Mulwala Solar Farm Modification 2

State Significant Development Modification Assessment Report (SSD-9039-Mod-2)

June 2026

Figure 2 | Modified project layout figure

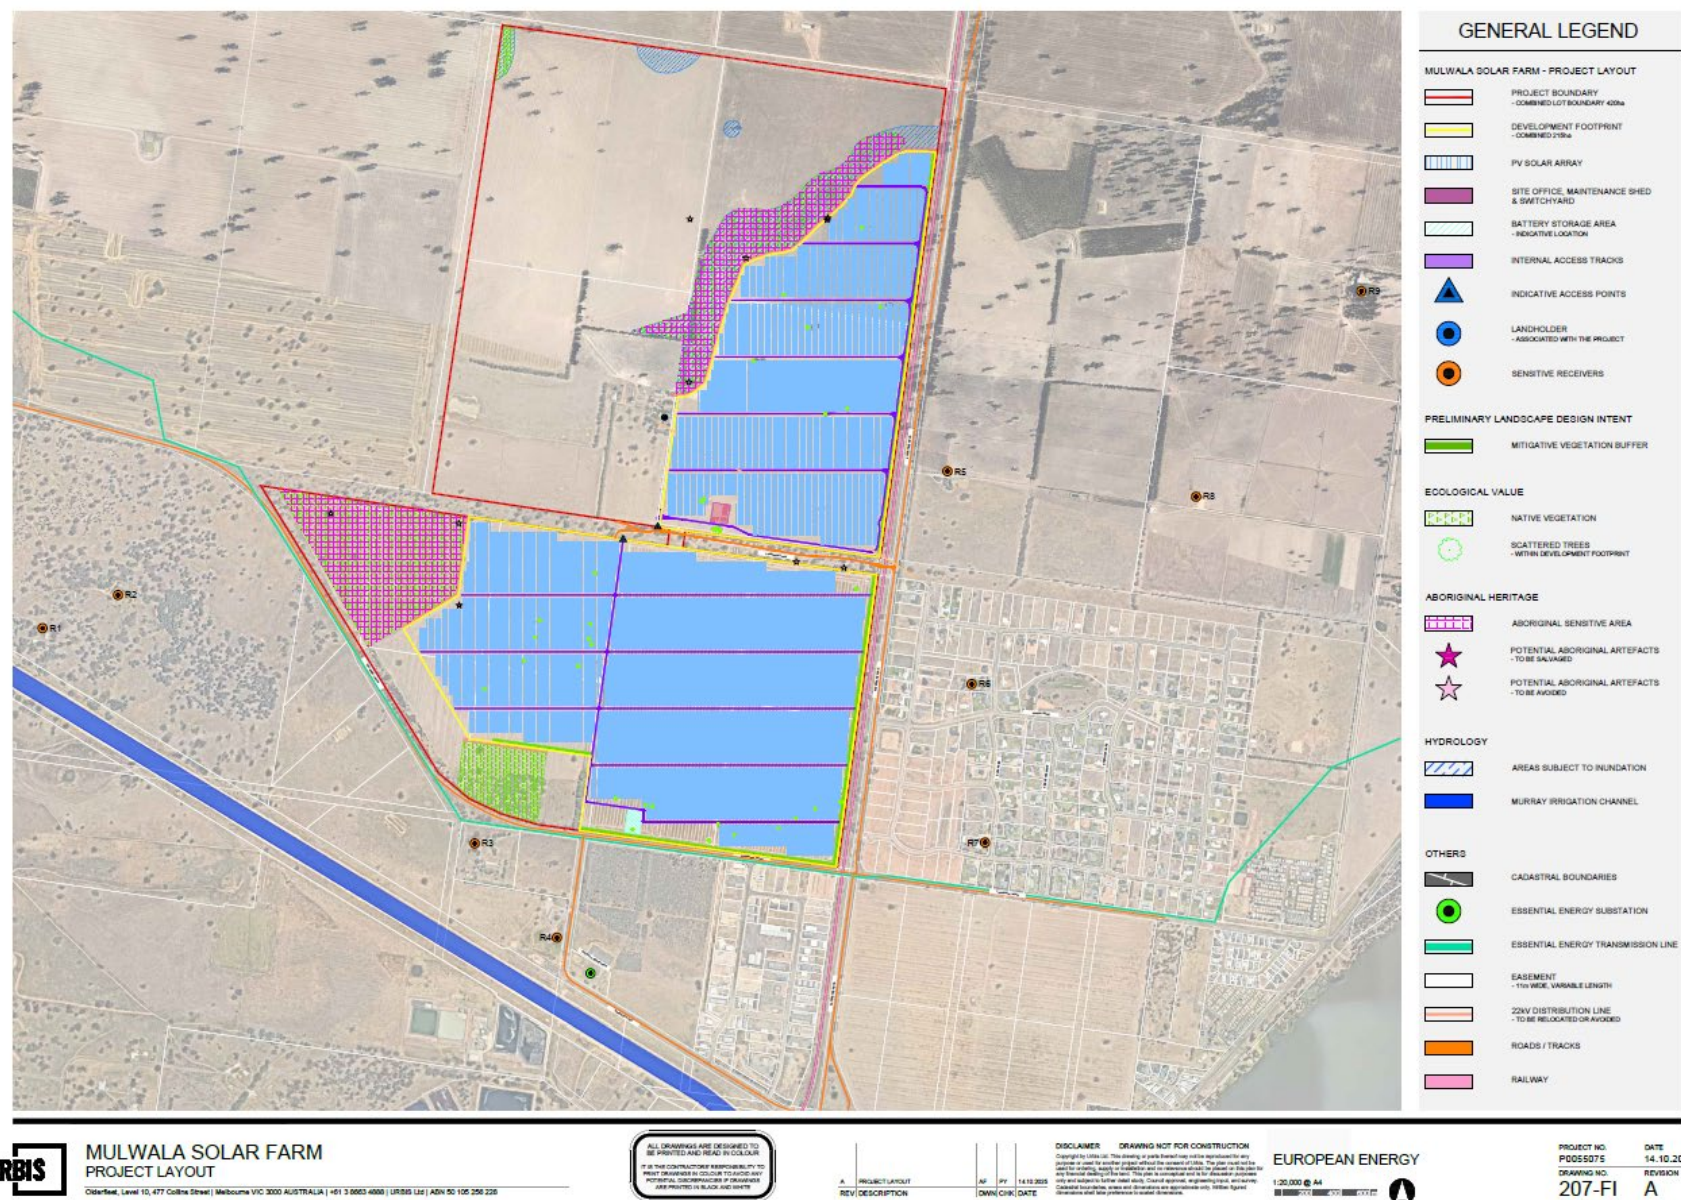
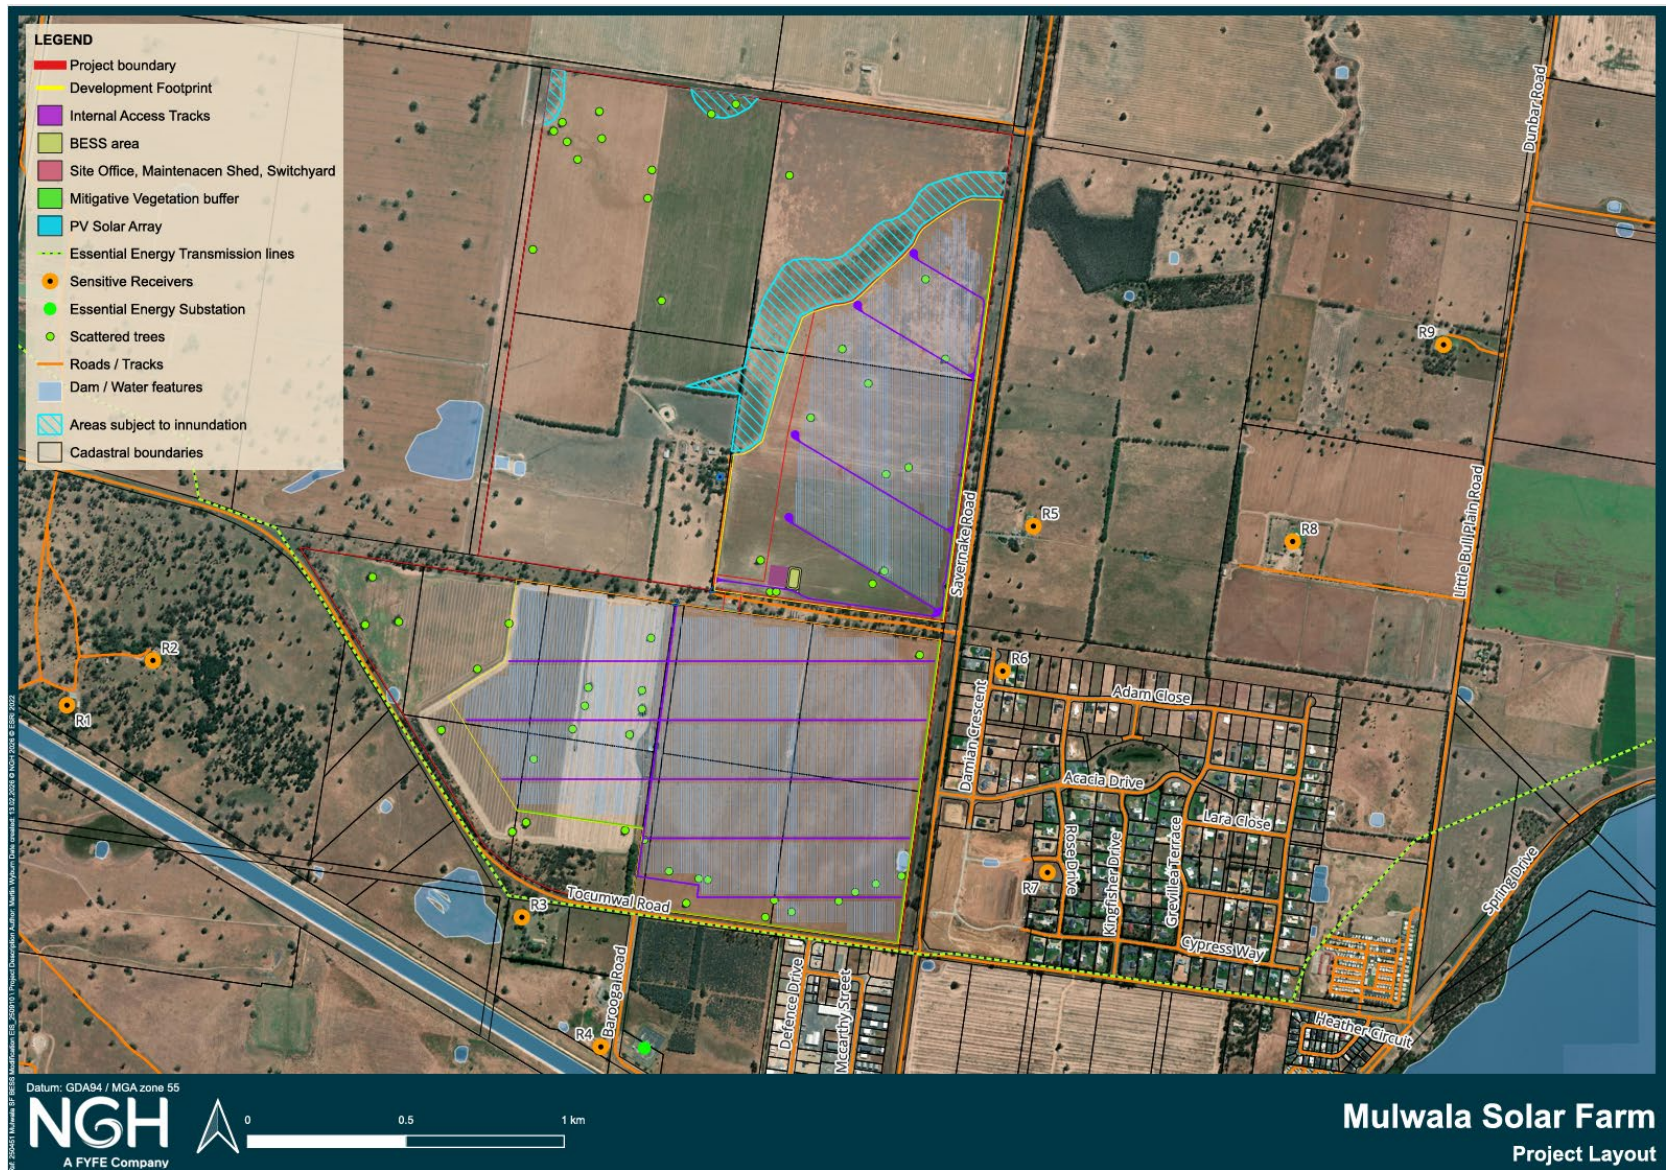
- relocate the approved location of the Battery Energy Storage System (BESS) from Lot 4 DP 1316892 (as identified in **Appendix 1** of the consent) to Lot 1 in DP 1316892, north of Lambruk Lane within the approved development footprint (see **Figure 2**).

- modify the solar array footprint within Lot 1 in DP1316892 and Lot 14 in DP1316892 to accommodate the BESS relocation and amend the location of the access tracks, resulting in a 11.2 hectare (ha) reduction in solar panel array, while maintaining the approved solar generation capacity of 80 MW.
